CITY OF ALBUQUERQUE

RE: **Lot 9 Block 13 Unit 5 SAD 227**
6519 Jade Dr. NW
Grading and Drainage Plan
Engineers Stamp Date 4/22/19 (E10D062)
Pad Certification Date 5/29/19

James D. Hughes, P.E.
Principal Engineer, Hydrology
Planning Department

ENGINEER'S SEAL	Lot 9, Block 13 Volcano Cliffs Unit 5 GRADING AND DRAINAGE PLAN	DRAWN BY JDC
DAVID SOULE NEW MEXICO REGISTERED PROFESSIONAL ENGINEER 4/22/19		DATE 04/20/2019
DAVID SOULE P.E. #14522	 Rio Grande Engineering 1606 CENTRAL AVENUE SE SUITE 201 ALBUQUERQUE, NM 87106 (505) 872-0999	SHEET # 1 OF 1
		JOB #

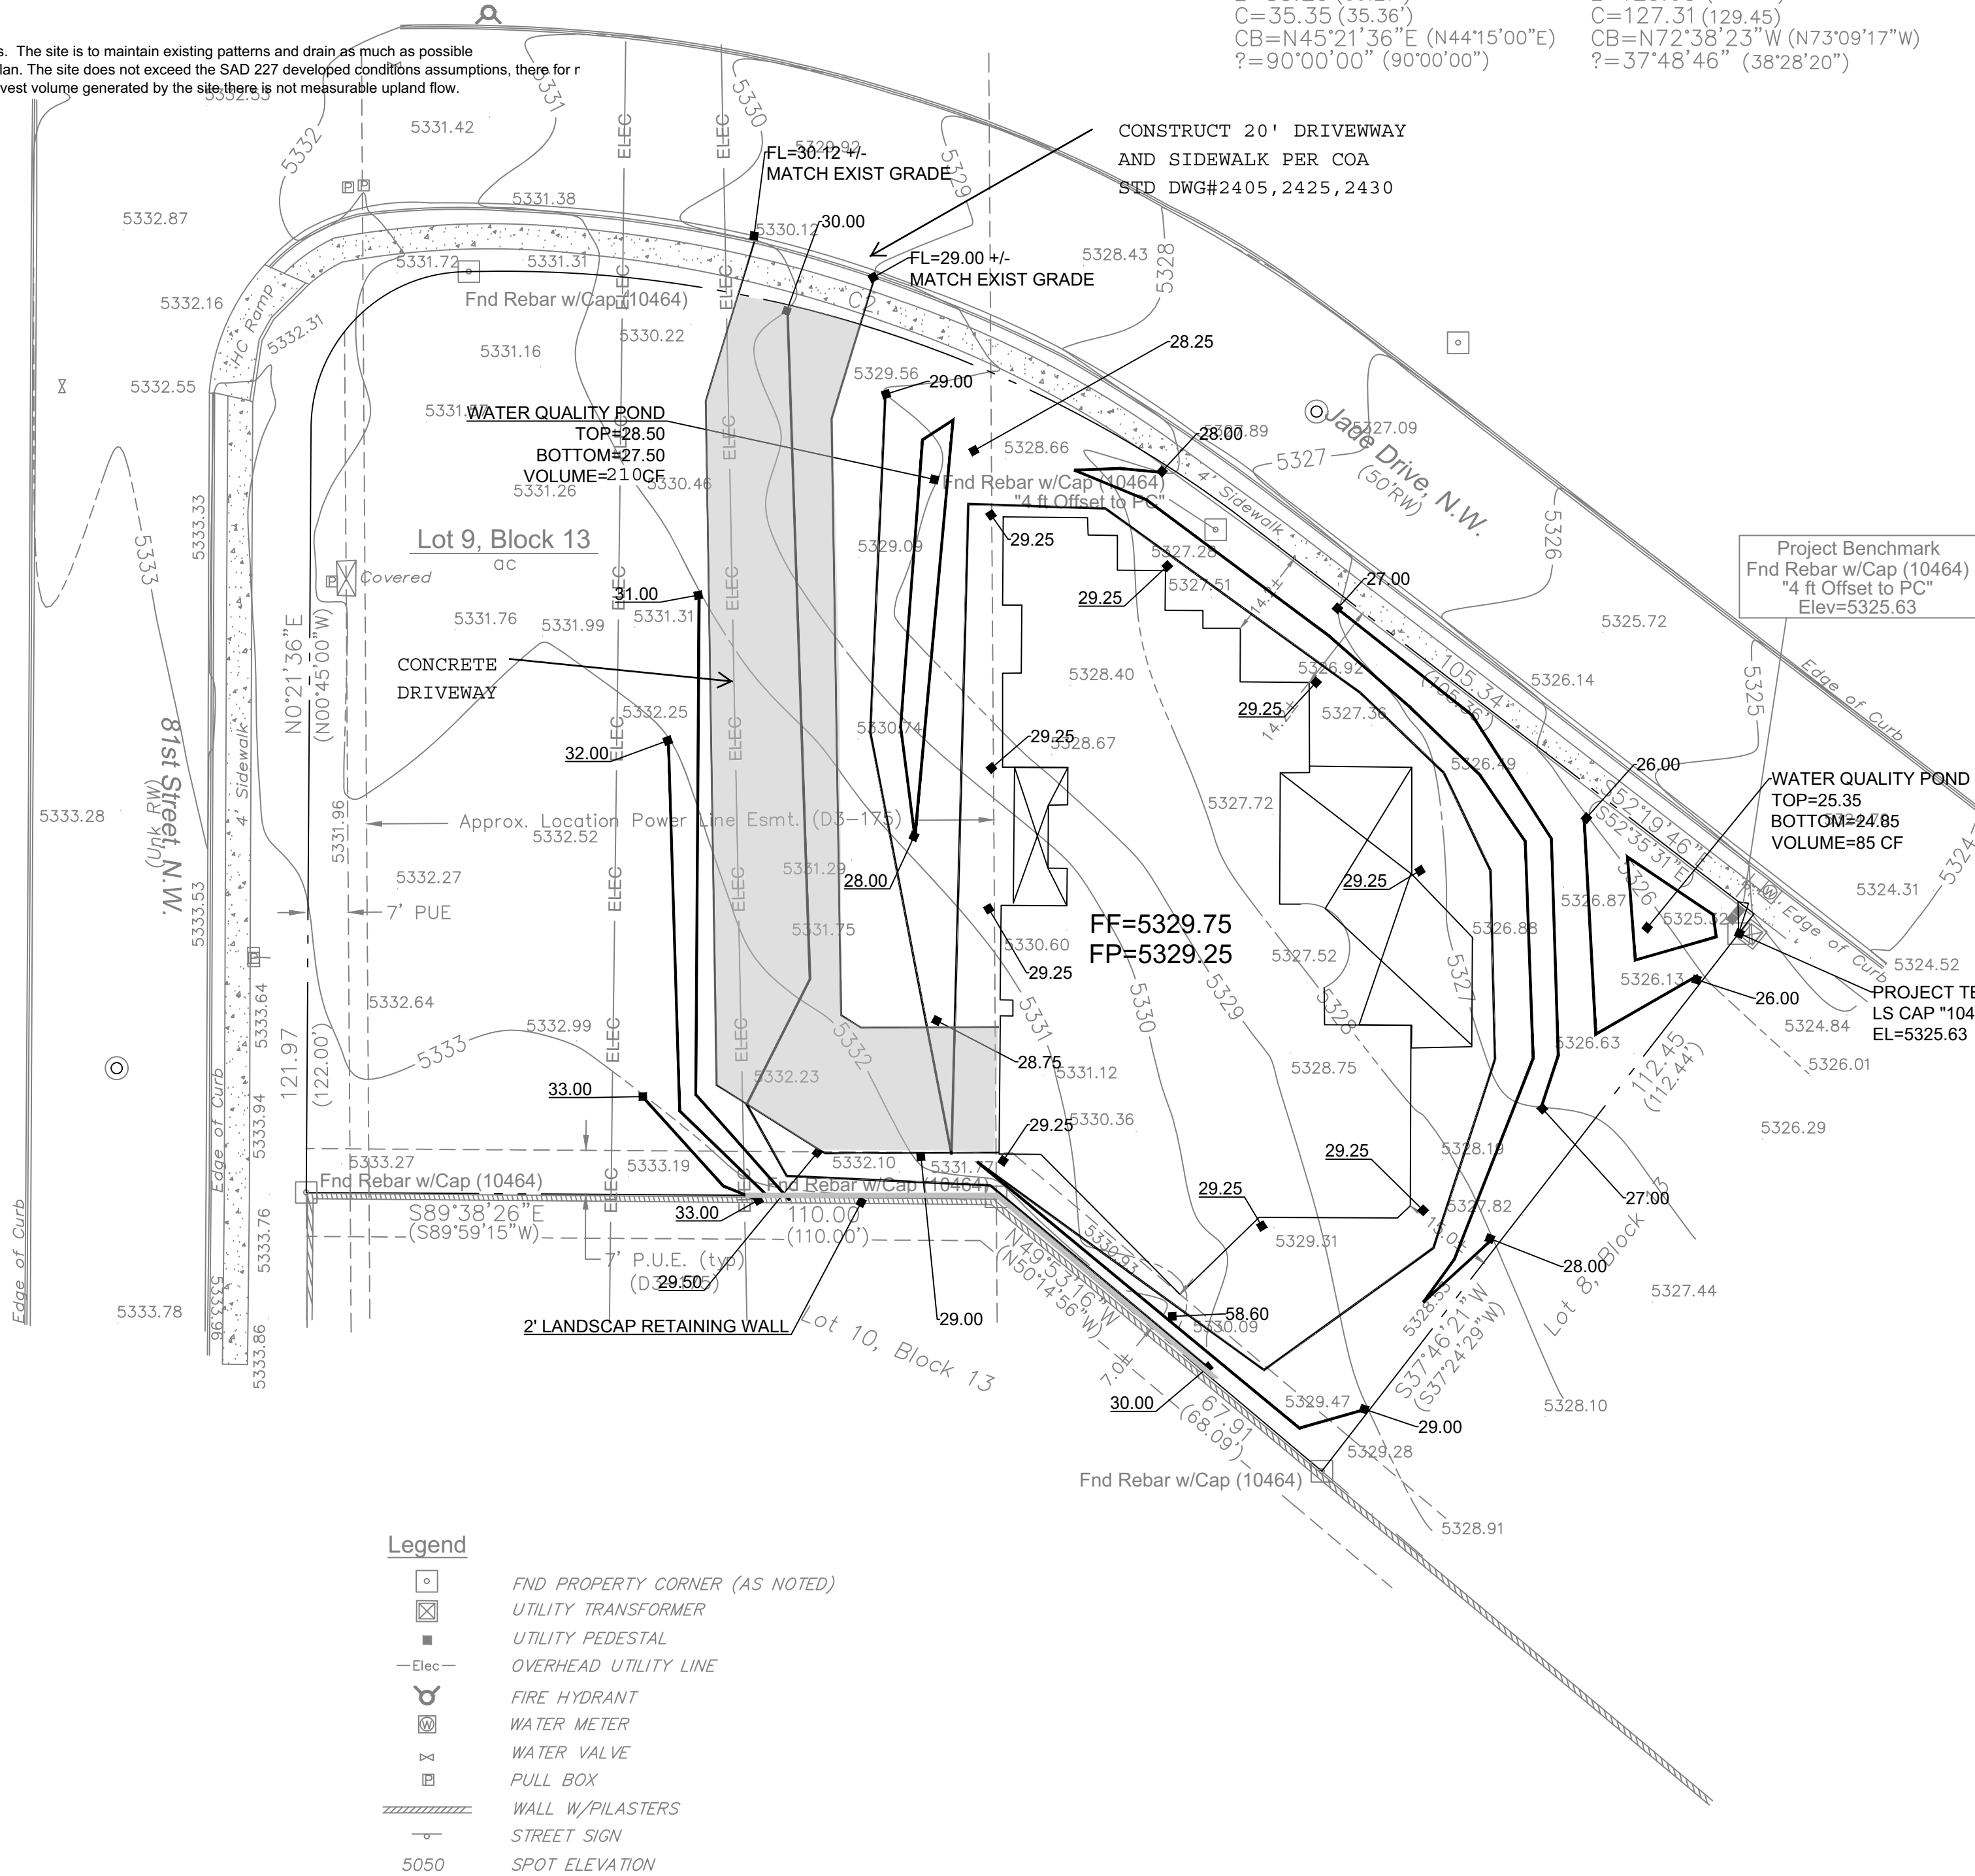
Based upon the information provided in your submittal received 6/19/19, this plan is approved for Building Permit.

Reiterate to the Owner/Contractor that a separate permit for a garden/retaining wall must be obtained, with the approved G&D plan dated 4/22/19.

Prior to Certificate of Occupancy release, Engineer Certification per the DPM checklist of this plan will be required.
